# **Town of Owego Planning Board**

Re: Special Use Permit #2122 Harry's Expressway 1423 State Route 96

This letter is in response to the comments provided by the Town Planning Board on November 22, 2022. The comments identified as "required" and "Strongly Consider" have been transcribed for reference followed by our response.

S-3

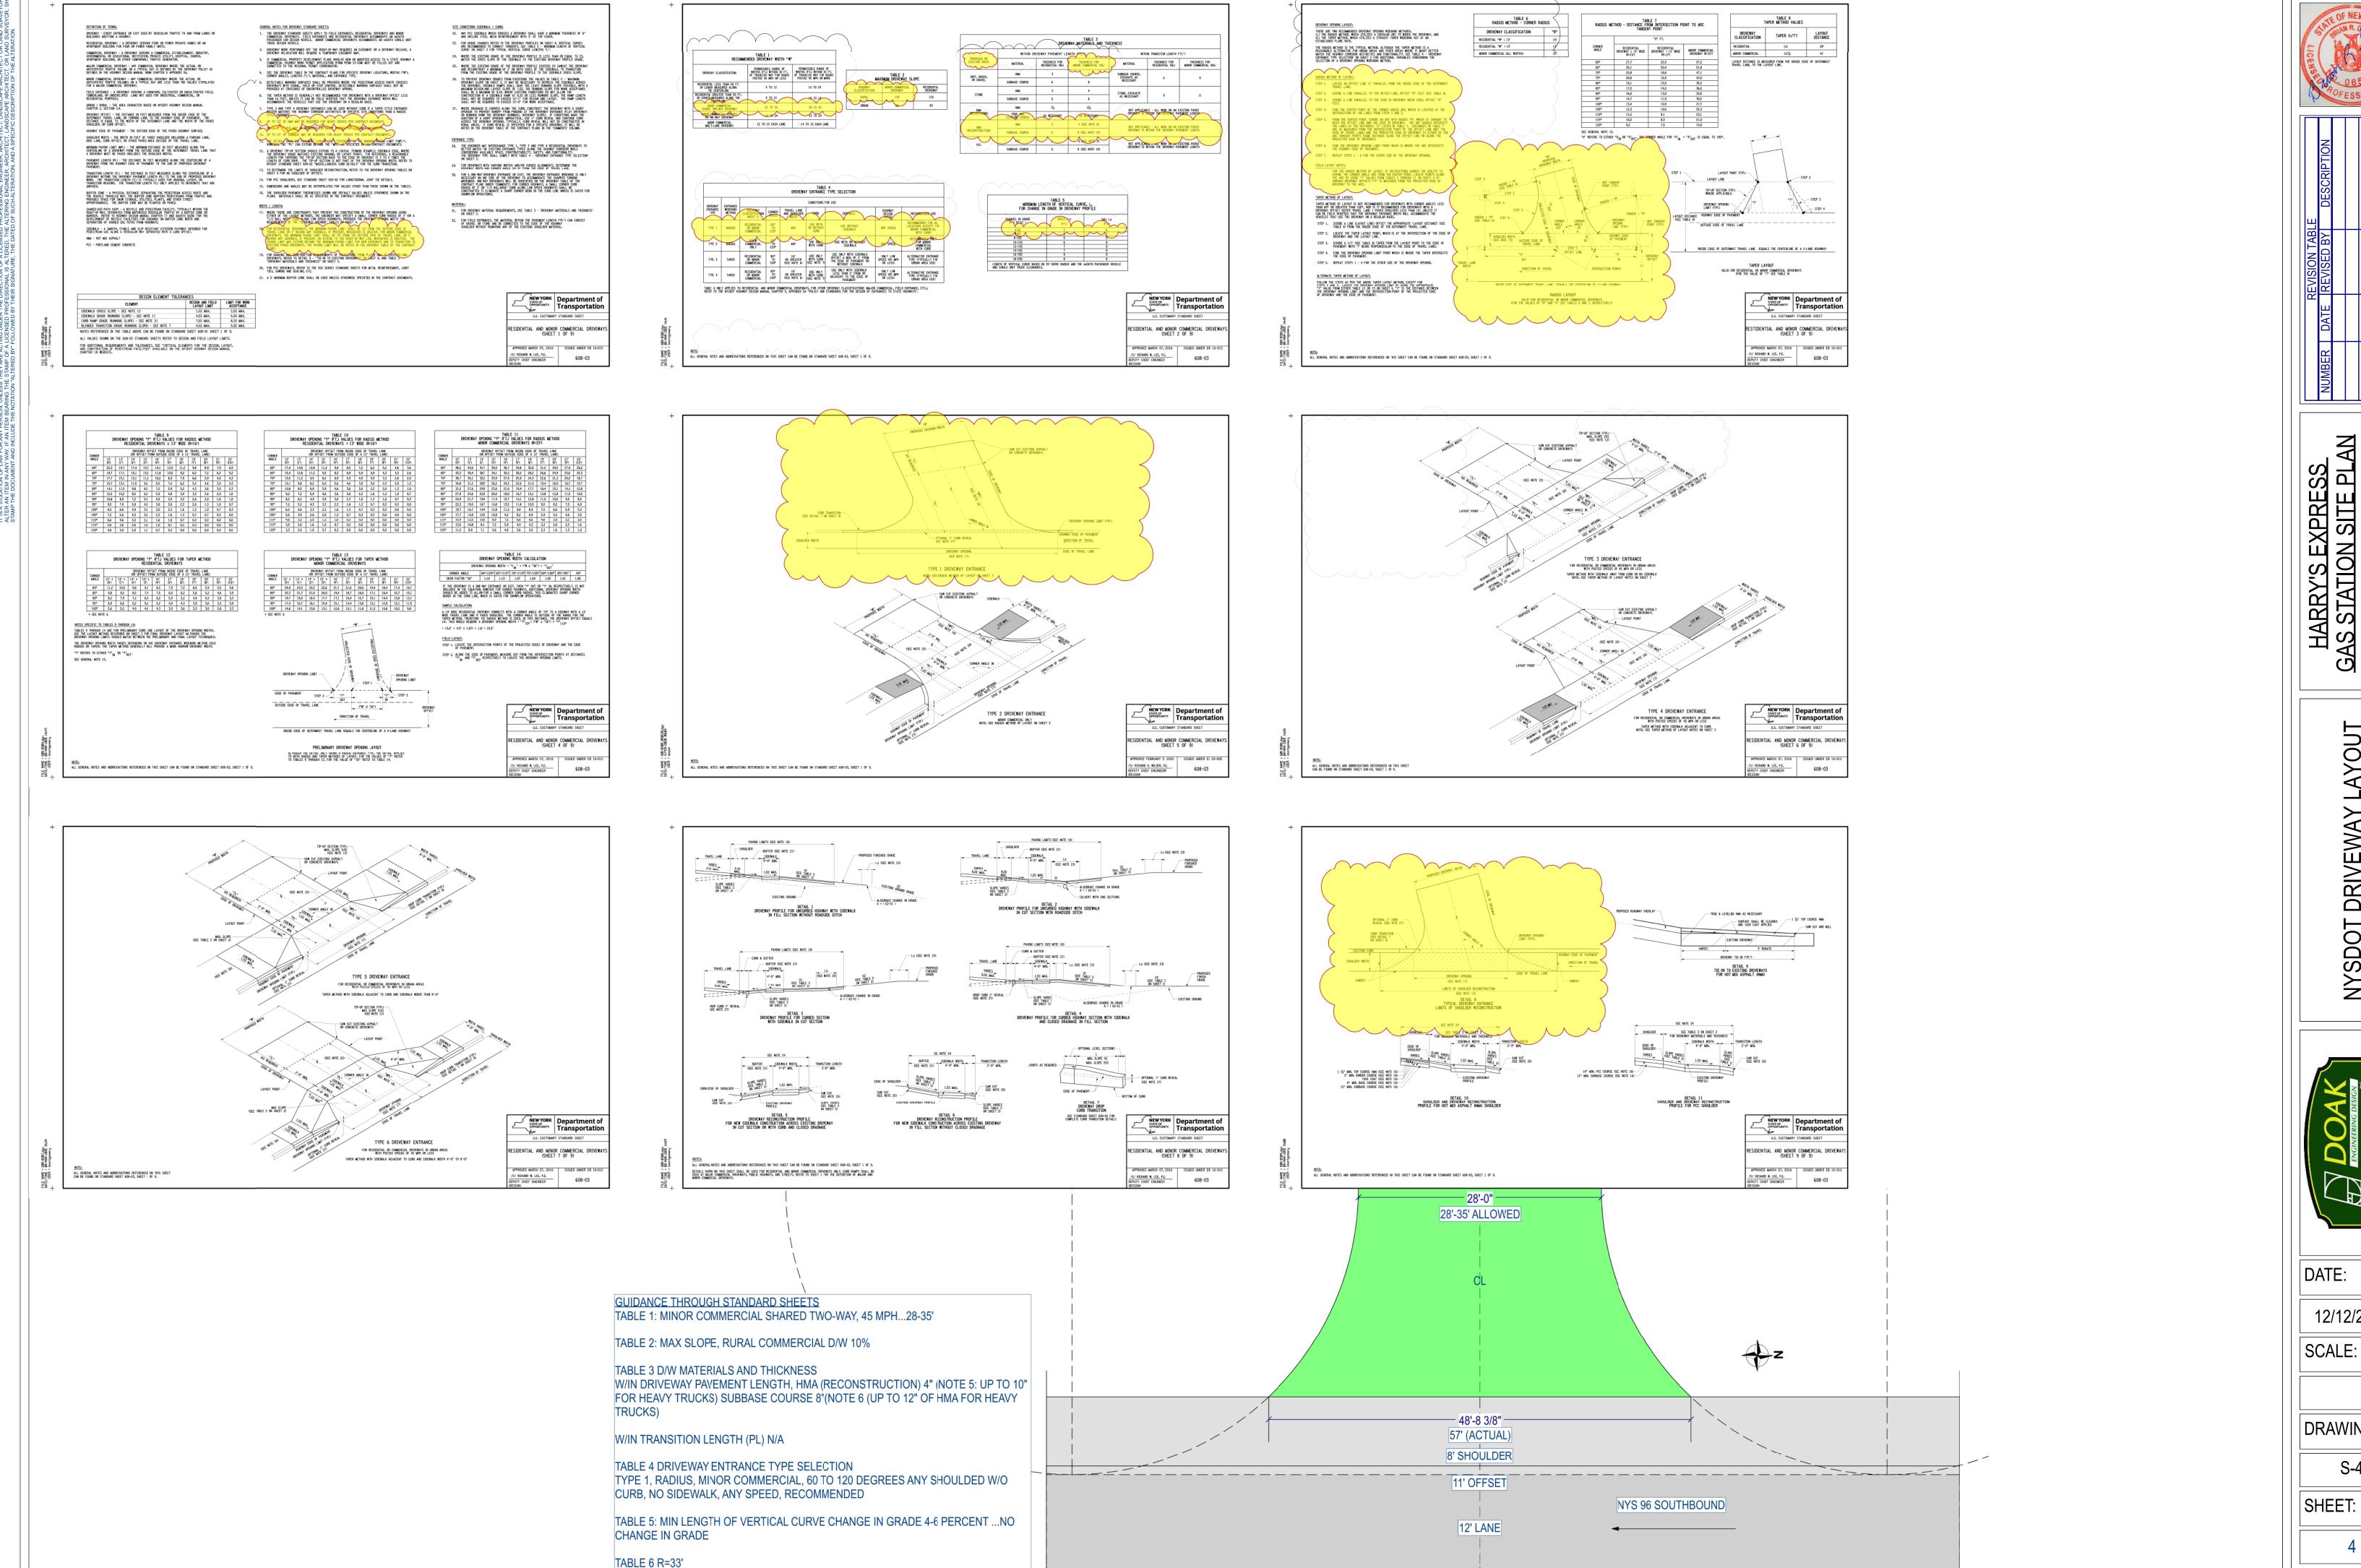
Mr. Tofte had three suggestions on the site plan: 1) access aisles next to each accessible parking space need to be eight feet wide and must include a sign for each space; 2) directional arrows painted on the parking lot could be removed because people do not pay attention to traffic flow when getting gas; and 3) the plan should show how fuel delivery trucks will turn around making deliveries.

The site plan showed eight cars at the fuel pumps. Mr. Wademan expressed concern that cars would have difficulty leaving the pumps nearest the liquor store parking area. Mr. Rieg agreed, stating that he was also concerned with the three parking spots near the driveway adjacent to

Route 96—pedestrian safety in particular (Sheet 2, SE Corner) as pedestrians must cross all lanes of vehicular traffic to get to the store.

Strongly consider the following changes to improve traffic flow a) show "future parking" spaces in the gravel area behind the Quonset hut; b) delineate phases, including one that shows removal of the Quonset hut, parking where the Quonset huts was, and perhaps moving/spacing the pumps further apart and towards where the Quonset hut currently sits, and c) move underground storage tanks to the rear of convenience store/on the gravel lot.

- 1. Show future parking area behind the Quonset hut: This is already shown on the Parking Study Sheet (S-3).
- Delineate phases including one that shows removal of the Quonset hut and parking where the Quonset hut was: A note has been added indicating the owner's future intention of demolishing the Quonset Hut. The seven additional parking places created, and the required access lane are shown on the Parking Study Sheet (S-3).
  - a. And perhaps moving/spacing the pumps further and towards where the Quonset Hut currently sits: After consulting with the contractor and the engineer, the owner clearly desires the pumps to be located where they are currently shown.

- 1. Remove directional arrows: Removed
- 2. Indicate fuel delivery truck turn around: WB-50 turning area indicated on Parking Study Sheet (S-3).
- 3. Three Parking post indicated in the southwest corner of the main parking lot: These are shown on the Parking study Sheet (S-3). As indicated on the sheet, these spots are shown as only potential parking spaces.
